## **MEETING NOTICE**

1. Call to Order
2. Consider approval of the Business Park North Committee meeting minutes of May 14, 2012.
3. David Wendt of Colorcon, Inc., requests site plan approval to relocate a dust collector and fan at 440 Business Park Circle, Business Park North.
4. Future agenda items.
5. Adjournment.

**SUGAR SPHERES  
DUST COLLECTOR  
ISOLATION  
VALVE RELOCATION**

I have completed a review of the proposed site plan for Colorcon, Inc., 440 Business Park Circle, Stoughton - Plan submitted 6/18/12. As noted, additional information may be required to be provided or shown on the plan.

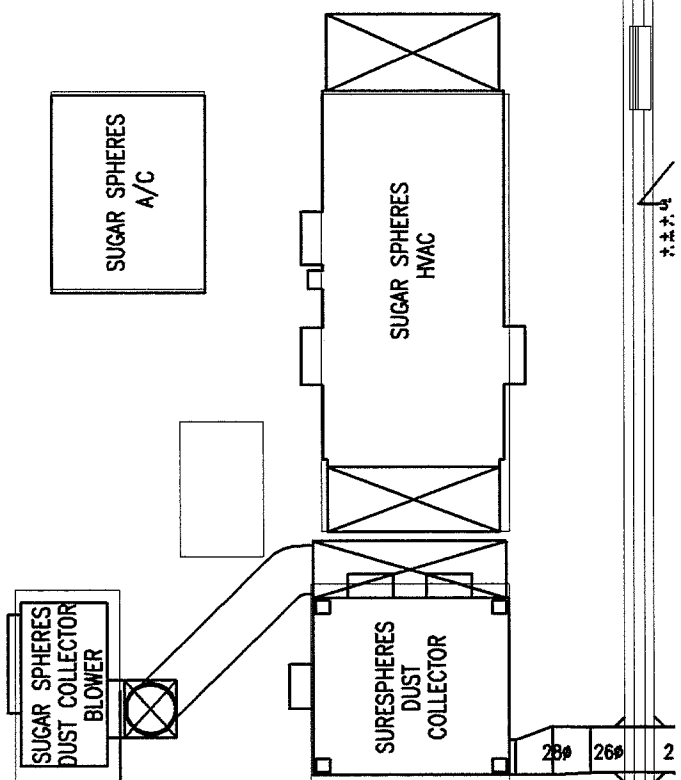
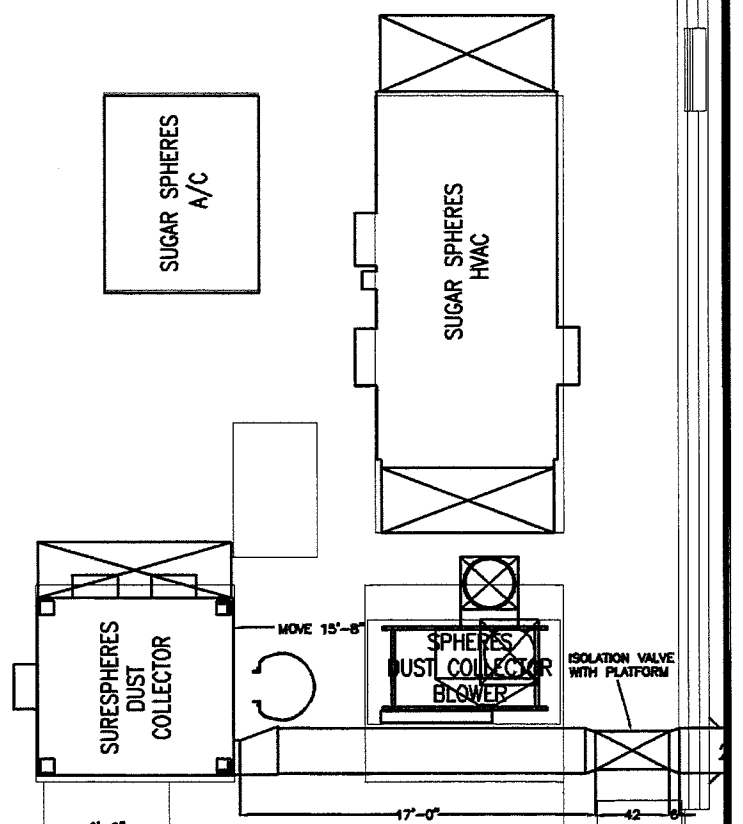
1. The property at 440 Business Park Circle is zoned PI – Planned Industrial. Light Industrial uses are permitted within the planned industrial district.
2. The Comprehensive Plan, planned land use map designates this property as General Industrial. **The Planned Land Use Map is in the process of being updated to planned industrial for this property.**
3. There are no changes that affect requirements related to parking, lighting or landscaping.
4. The minimum paved surface setback is five feet from the side or rear lot line and ten feet from a right-of-way. The proposed cement driveway addition meets this requirement.
5. The setback requirement for accessory structures is 4 feet from the side and rear lot lines. Additionally, no structures may be placed within an easement. The proposed site plan meets these requirements.

- b. "All electrical and air conditioning structures, including towers and air handling units, regardless of location and whether on the roof or otherwise, shall be concealed by landscaping or by decorative screening materials which form an integral part of the design." **Existing screening is sufficient.**
